## **Bid Package 02 - Construction Bulletin 05**

**05/05/2020**

**Canadian County Expo Center  
3001 Jensen Road East  
El Reno, OK 73036**

SHEET TITLE:  
ELECTRICAL POWER PLAN -  
AREA B

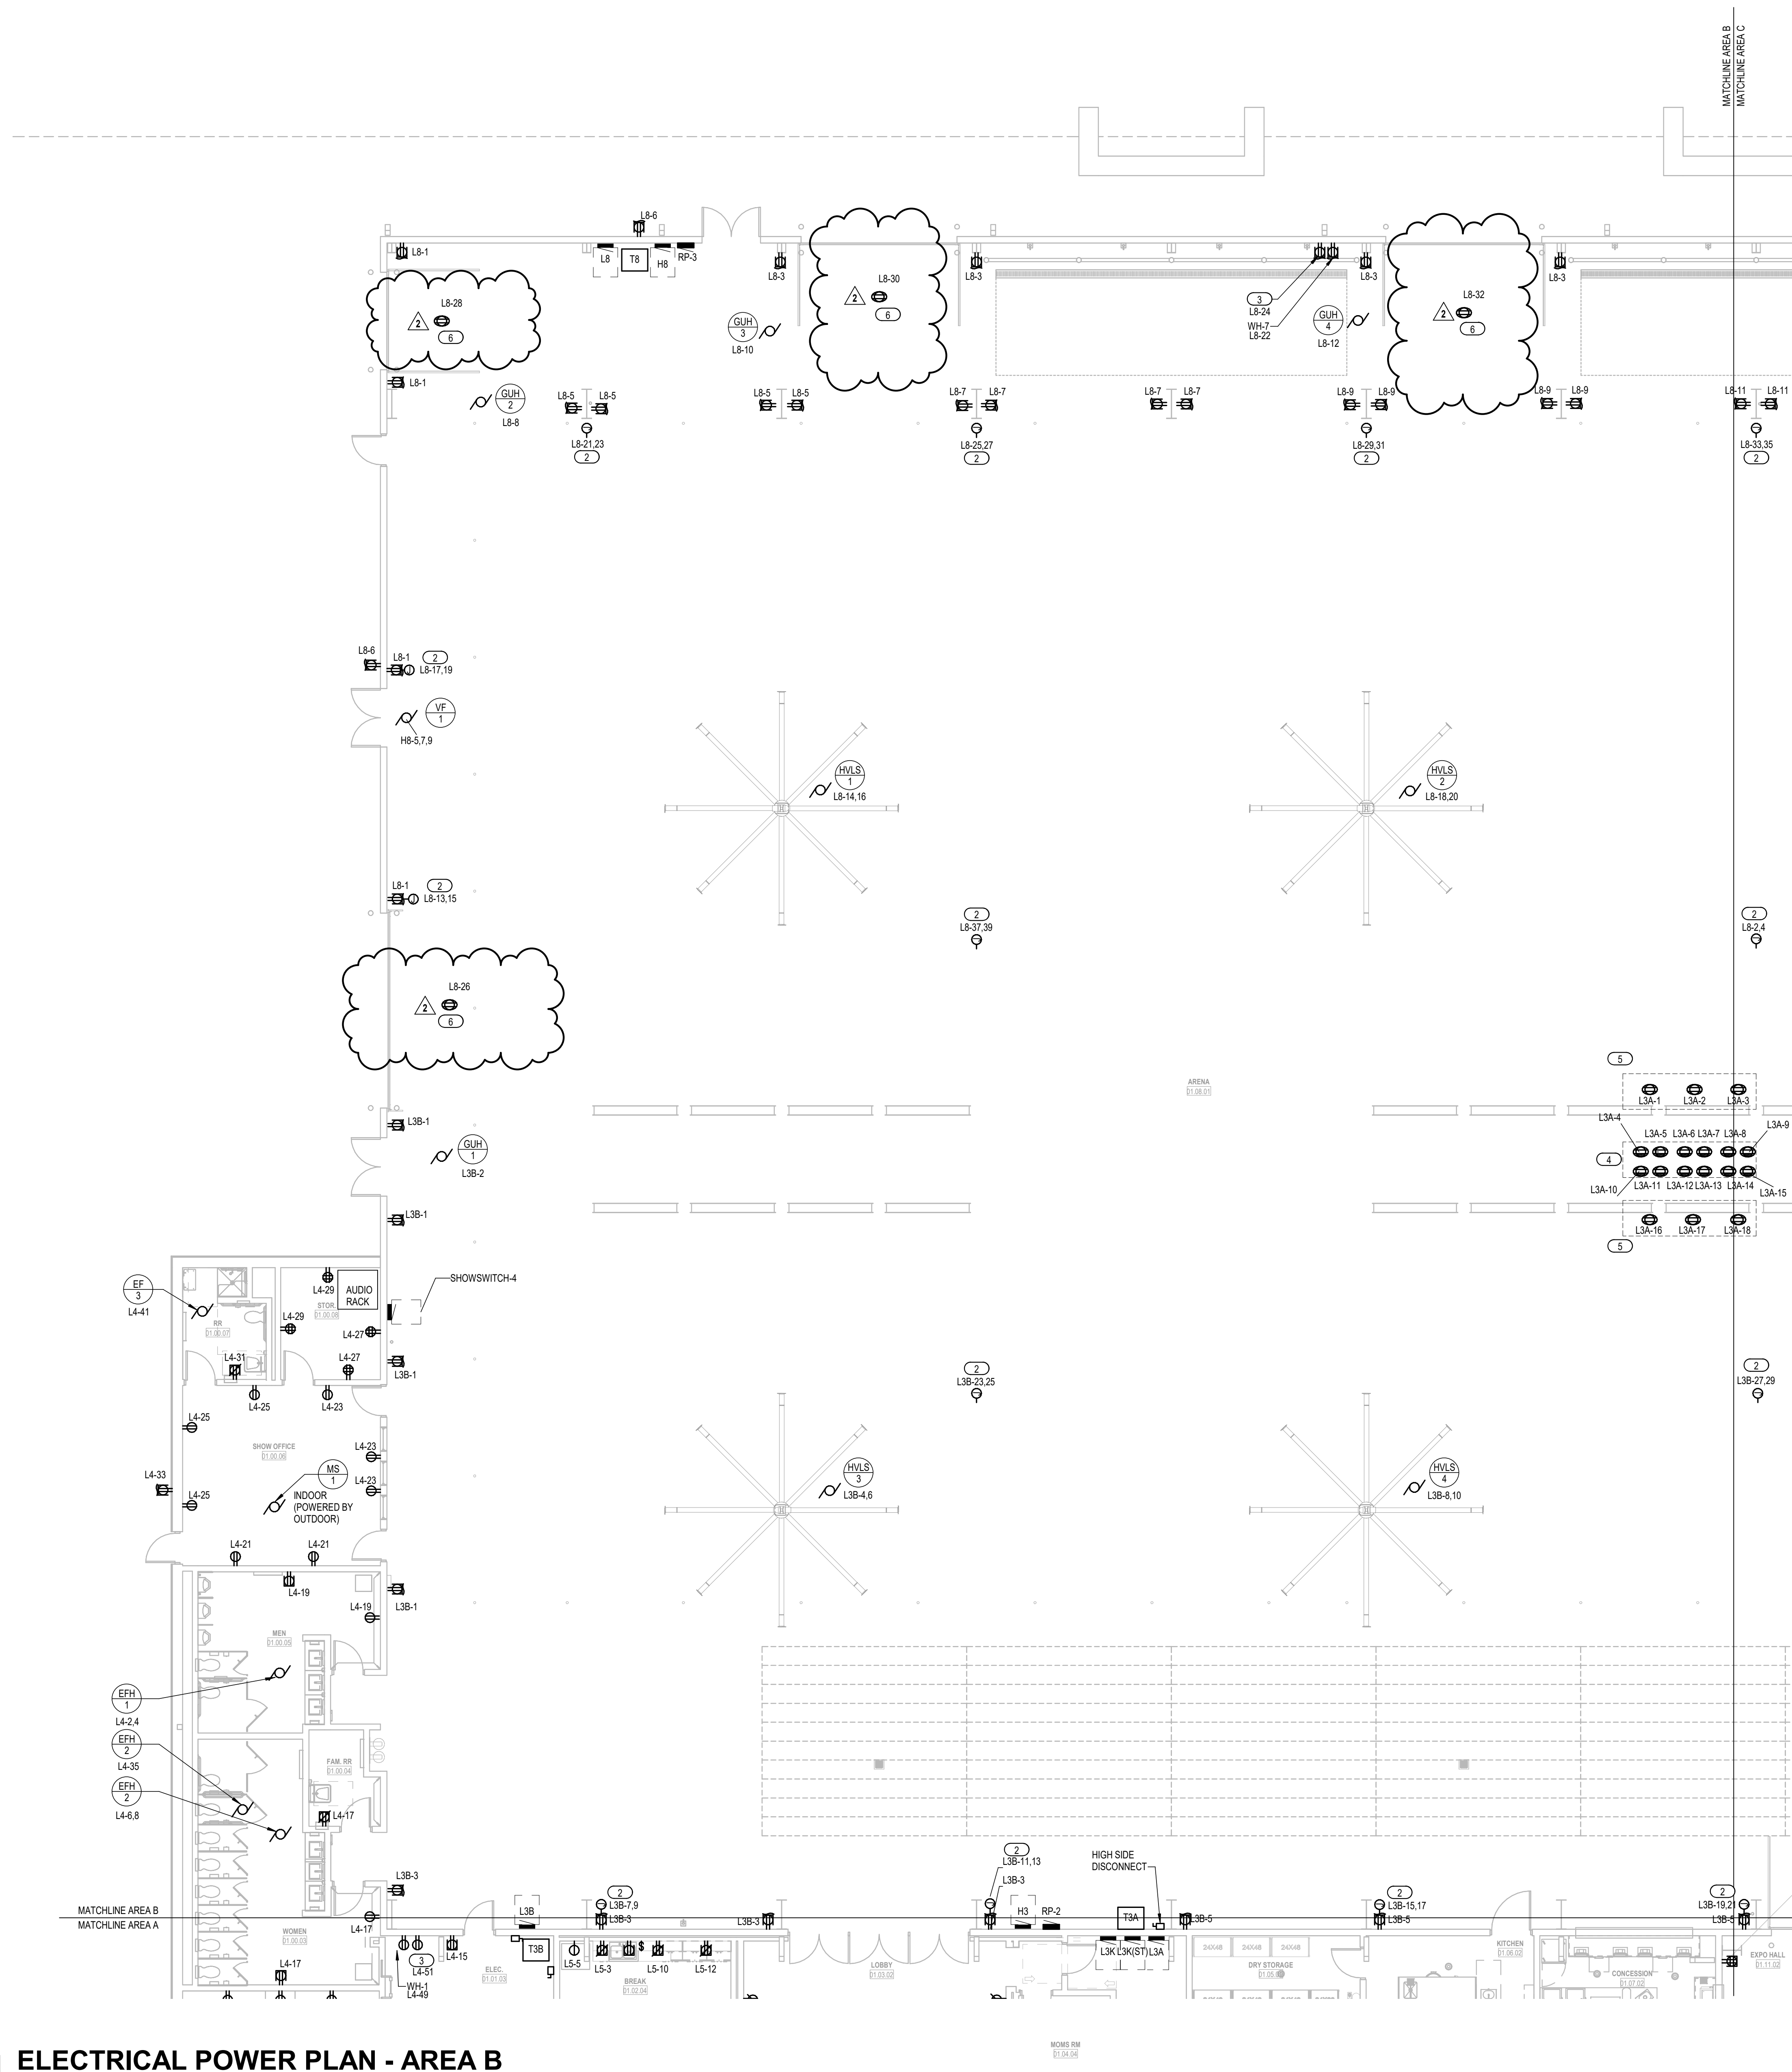
- a. Removed stray disconnect in room Comm 01.02.03.
- d. Sheet E2-1B Electrical Power Plan - Area B
  - a. Added ceiling mount receptacles for overhead doors.

- Sheet E2-1B Electrical Power Plan - Area B
  - Added ceiling mount receptacles for overhead doors.
- Sheet E2-1C Electrical Power Plan - Area C
  - Added ceiling mount receptacles for overhead doors.

# 1 ELECTRICAL POWER PLAN - AREA C

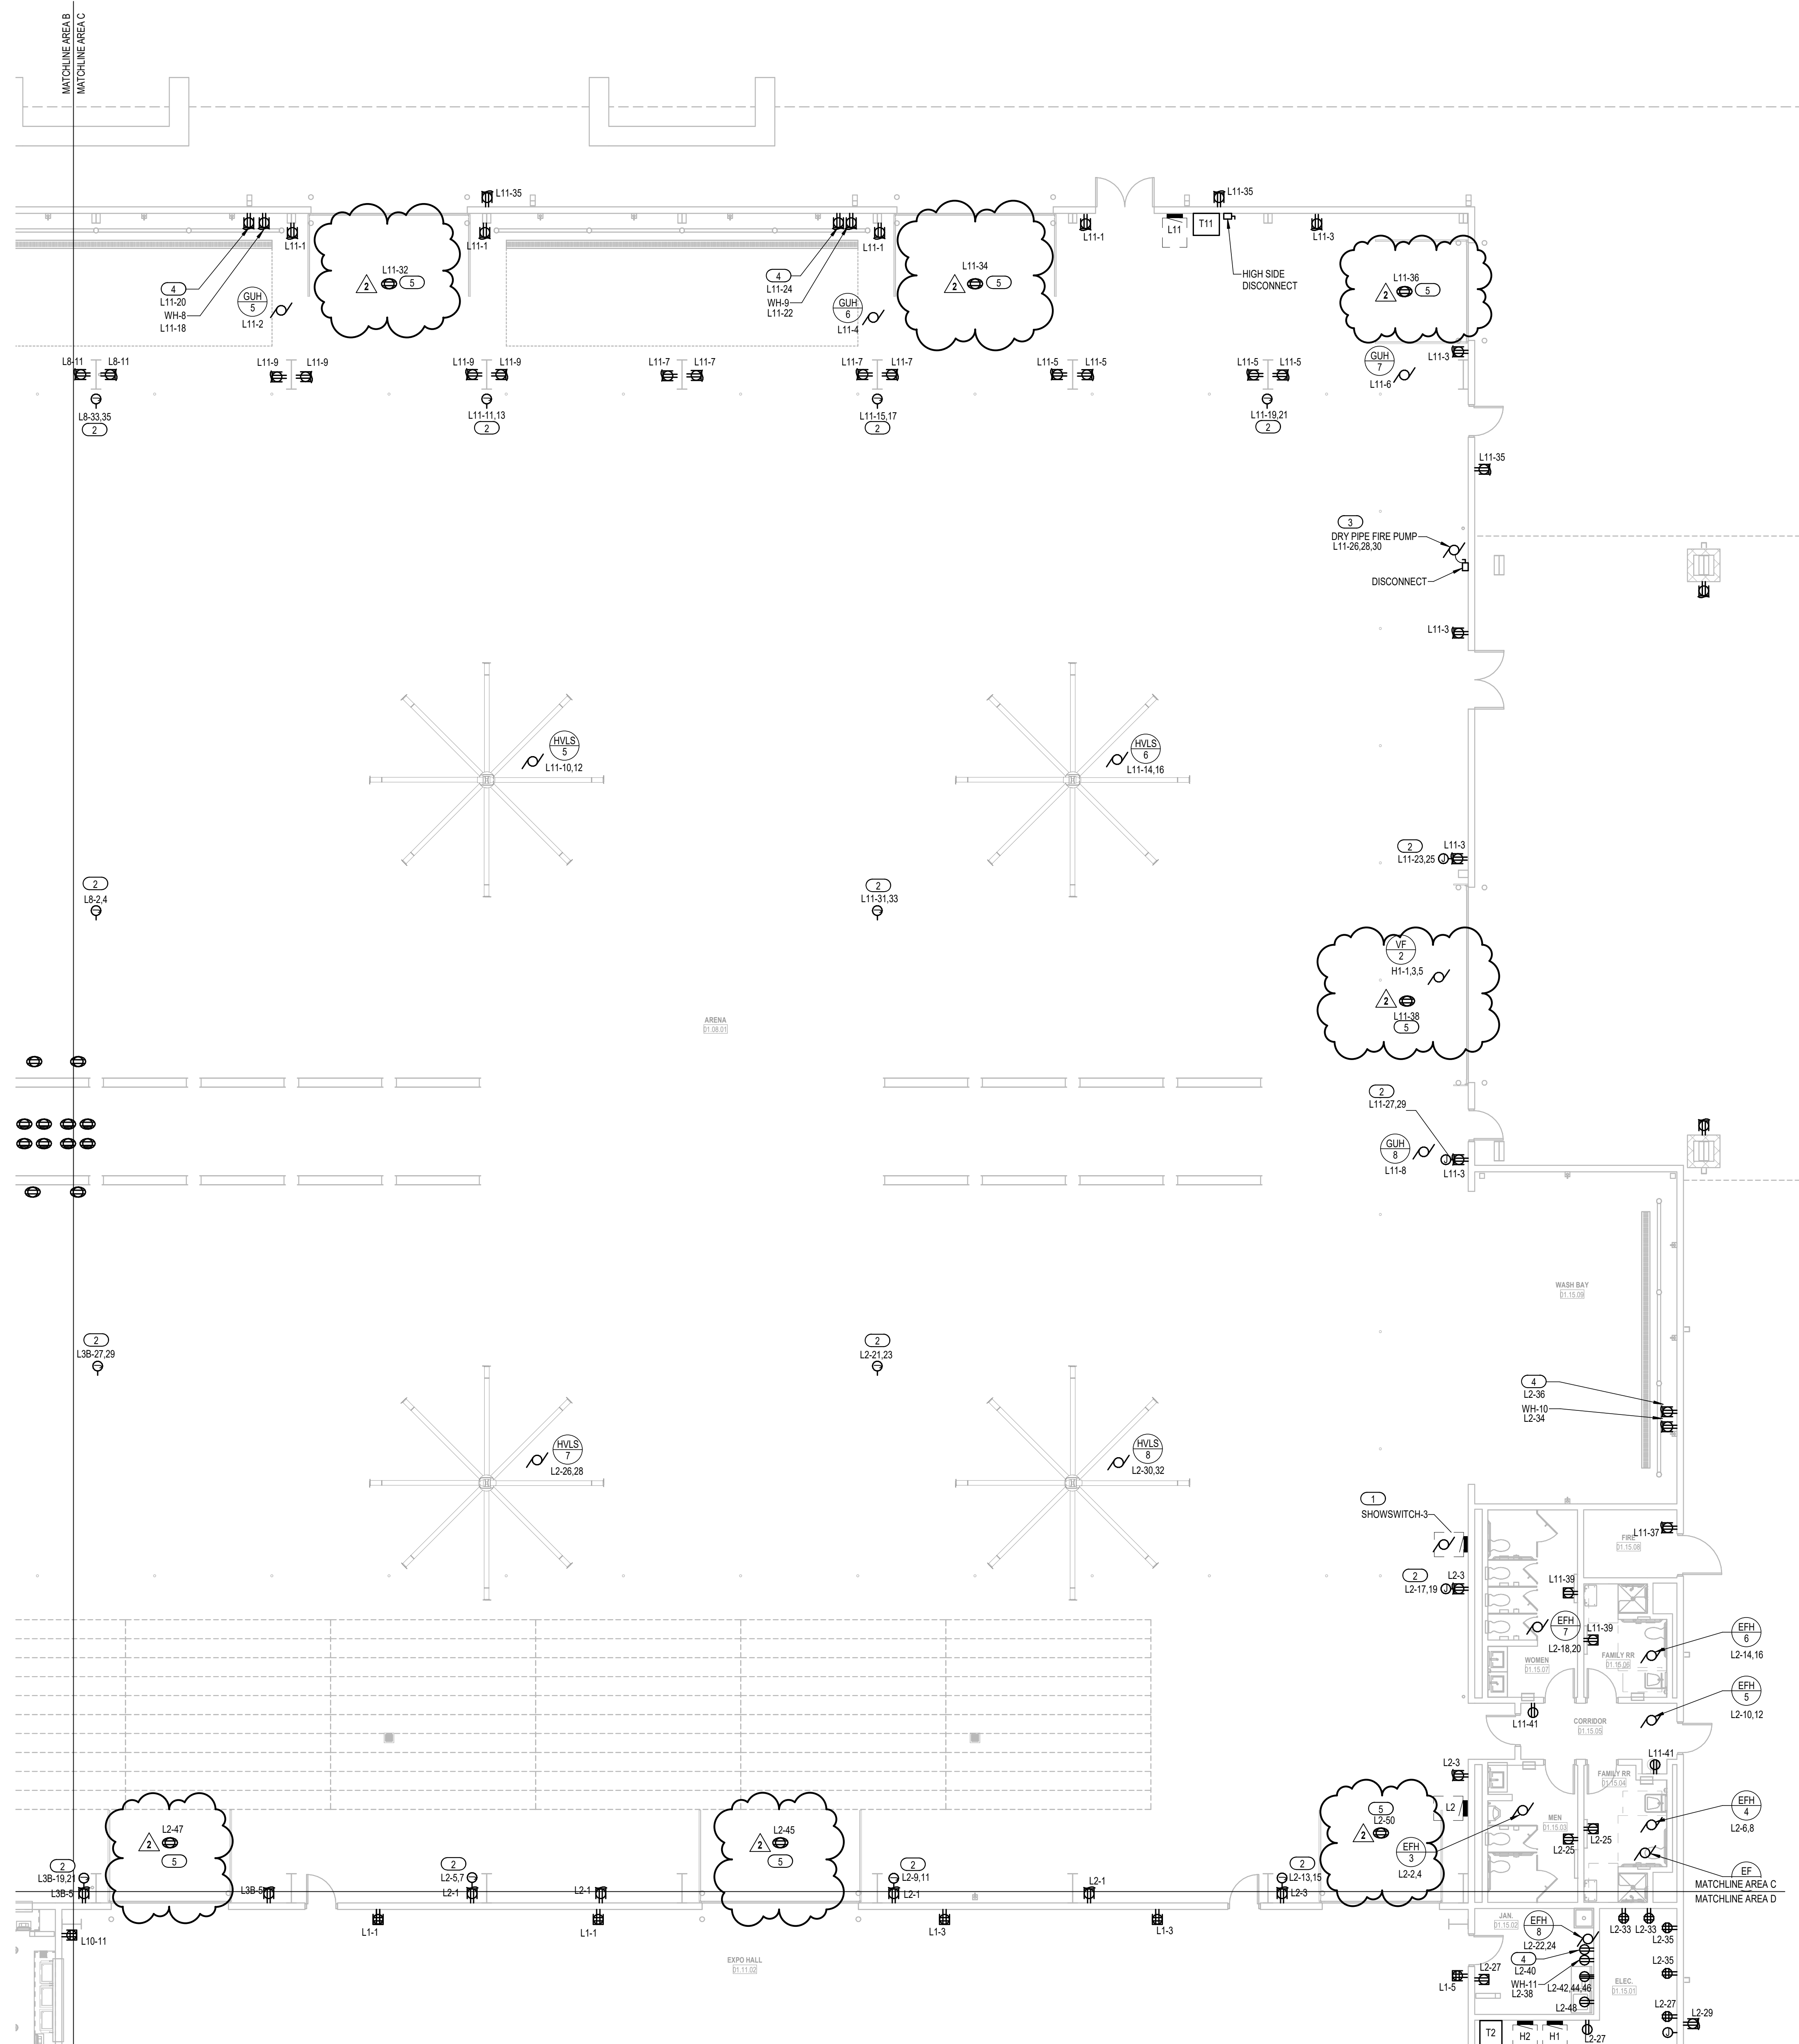
- e. Sheet E2-1C Electrical Power Plan - Area C
  - a. Added ceiling mount receptacles for overhead doors.
- f. Sheet E2-1D Electrical Power Plan - Area D

# 1 ELECTRICAL POWER PLAN - AREA D

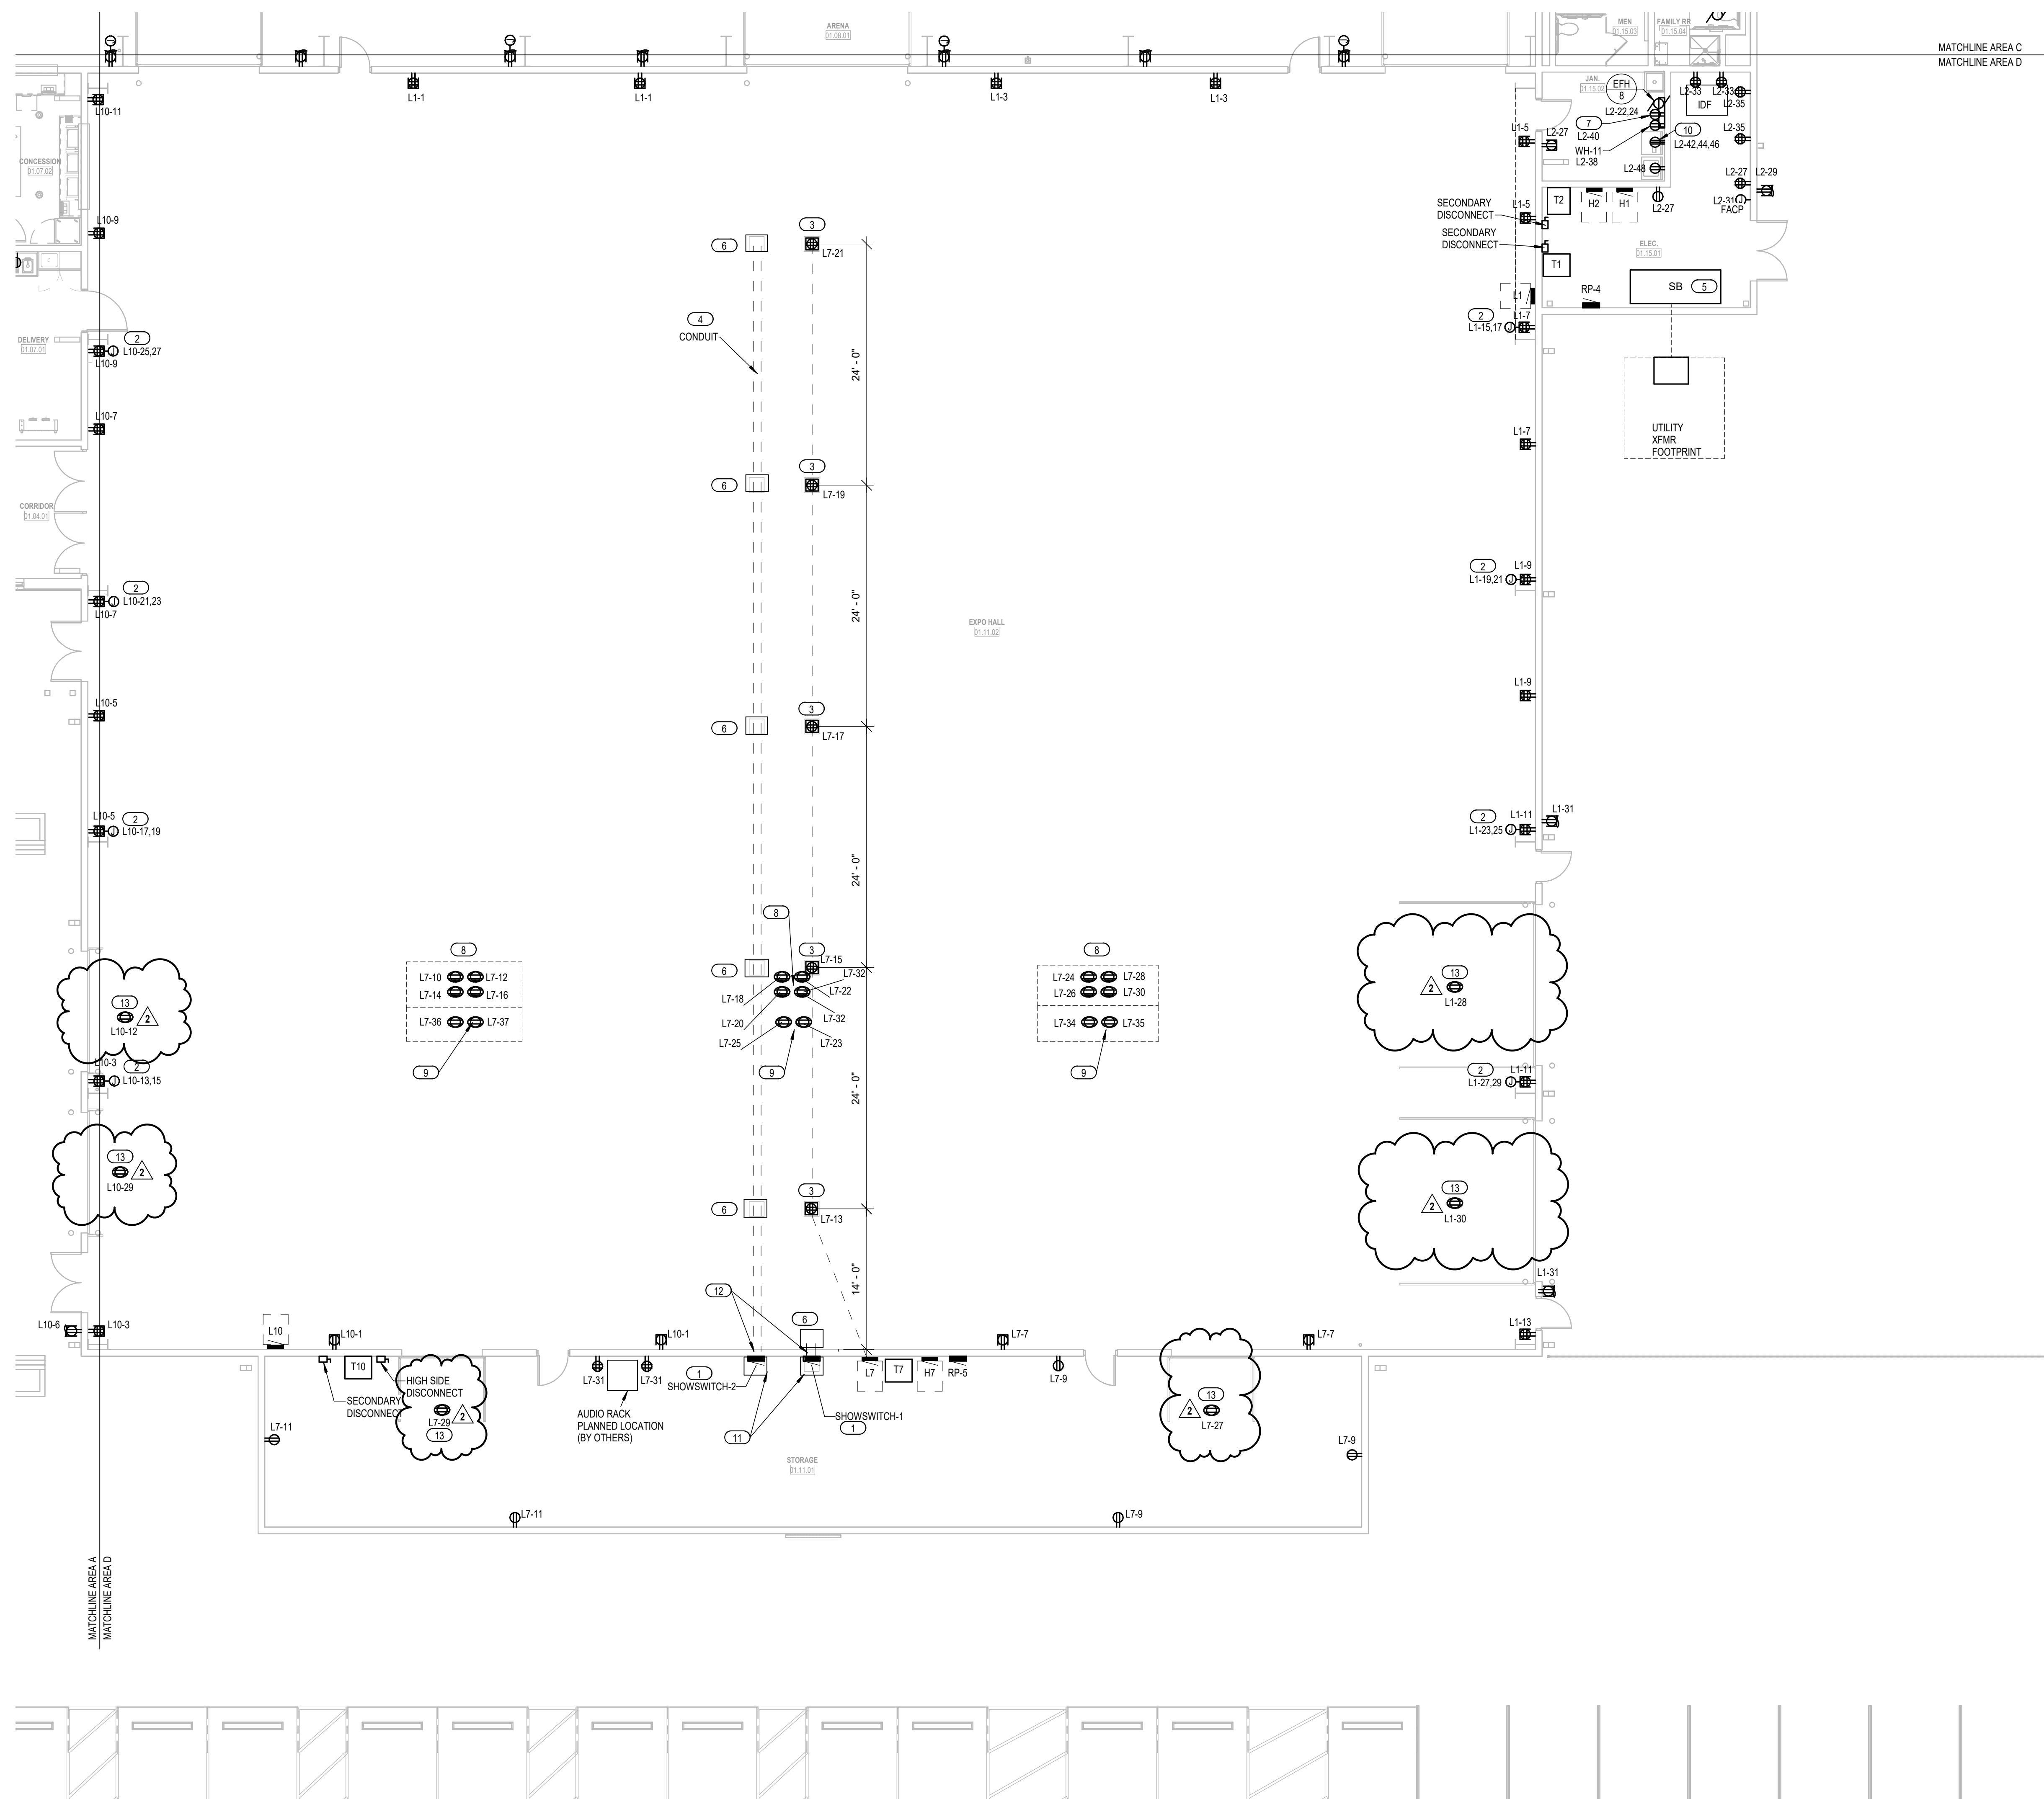
- a. Added ceiling mount receptacles for overhead doors.
  - b. Added info for key note three floorboxes.
- g. Sheet E2-1F Electrical Power Plan – Alt 1 Barn

- Sheet E2-1D Electrical Power Plan - Area D
  - Added ceiling mount receptacles for overhead doors.
  - Added info for key note three floorboxes.
- Sheet E2-1F Electrical Power Plan – Alt 1 Barn
